**ADDENDUM NUMBER 1**  
*Front Street Bridge Rehabilitation*  
BR-AEC-0424  
April 4, 2024

To all holders of Bid Documents, please be advised of the following:

STATE OF NORTH CAROLINA  
**STATE HIGHWAY COMMISSION**  
RALEIGH  
STRUCTURAL STEEL DETAILS

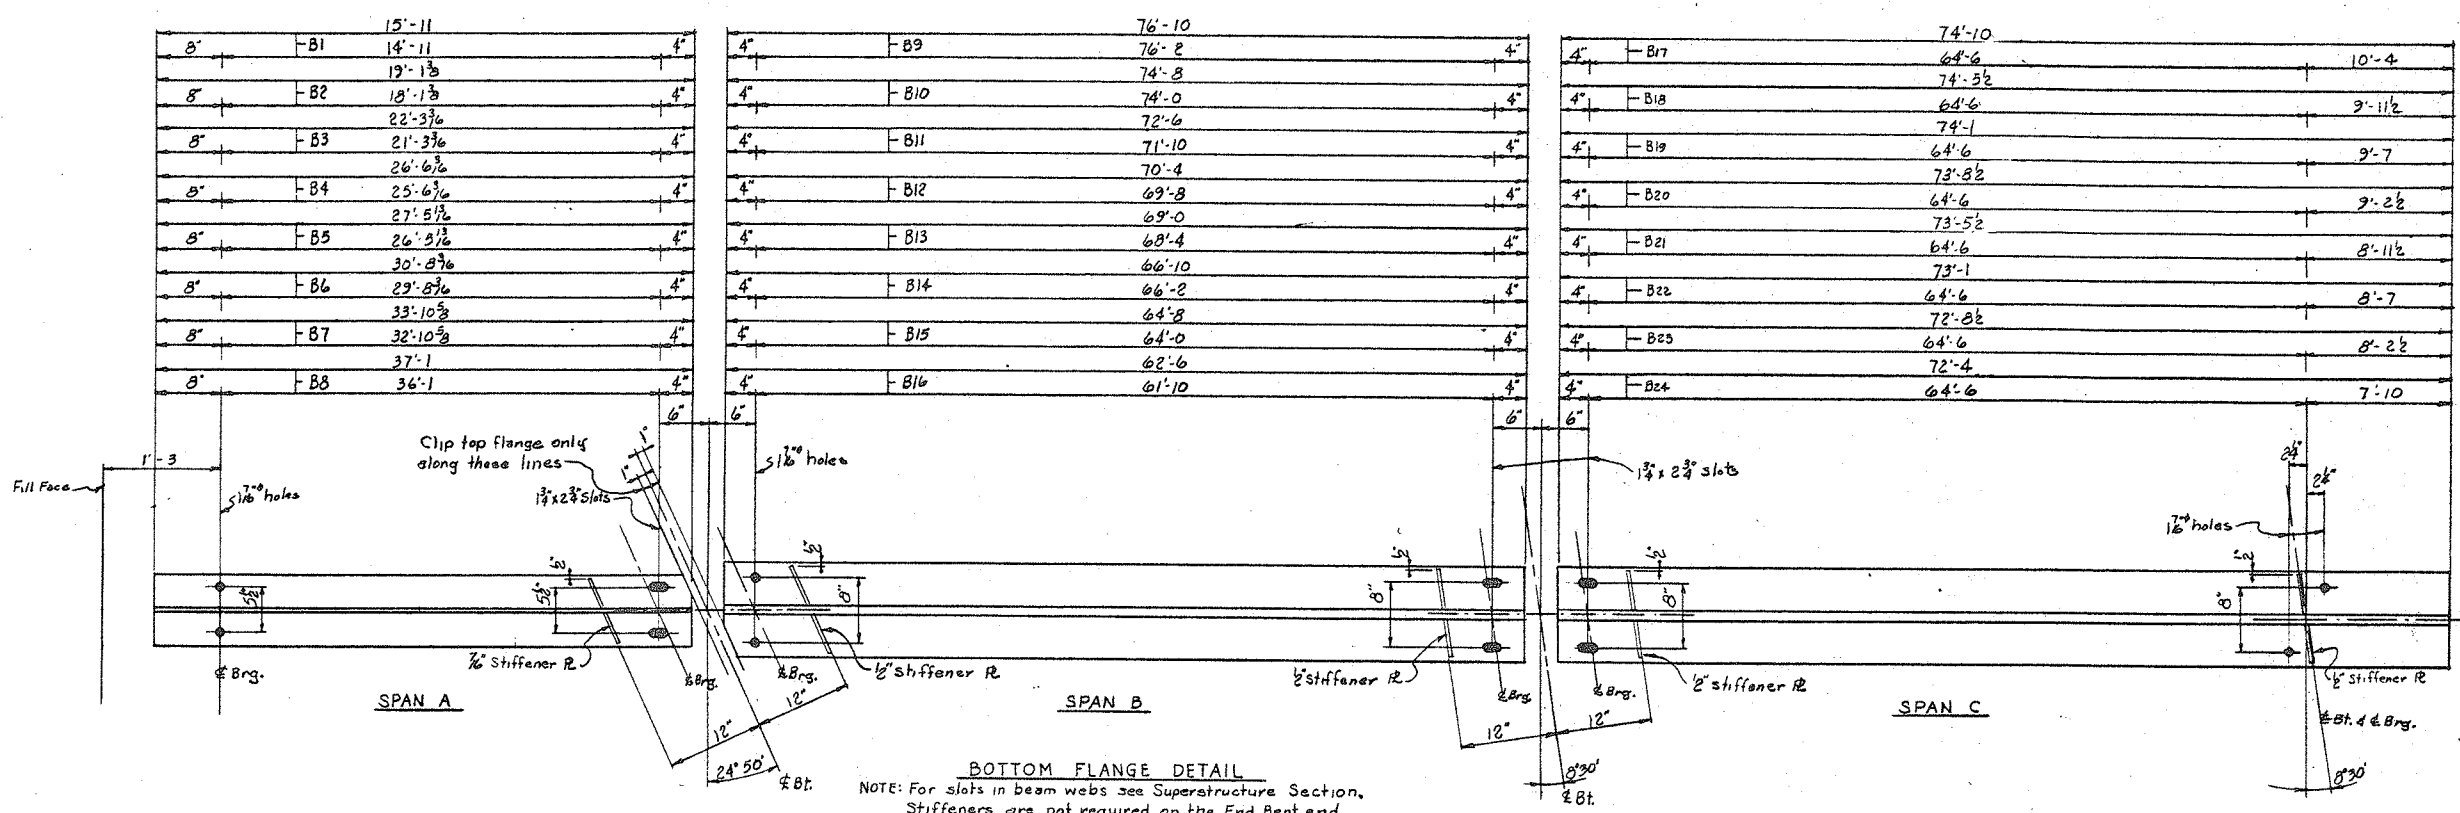
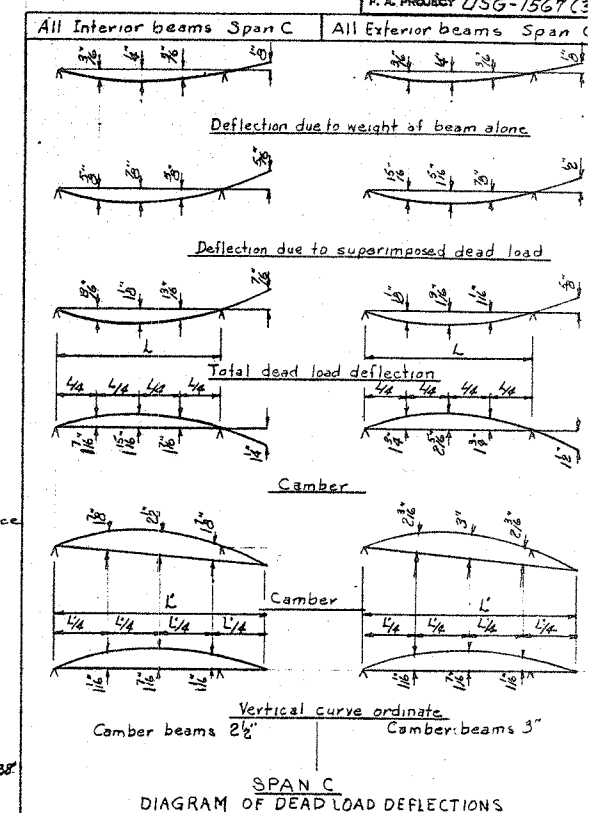
2. *Do you have to top flange width of the girders?*

**Answer: The existing plans show the existing beam data. Beam sizes vary, and include shapes 24WF76, 27WF102, 30WF116, 36WF170, 36WF160, 36WF150, 36WF135.**
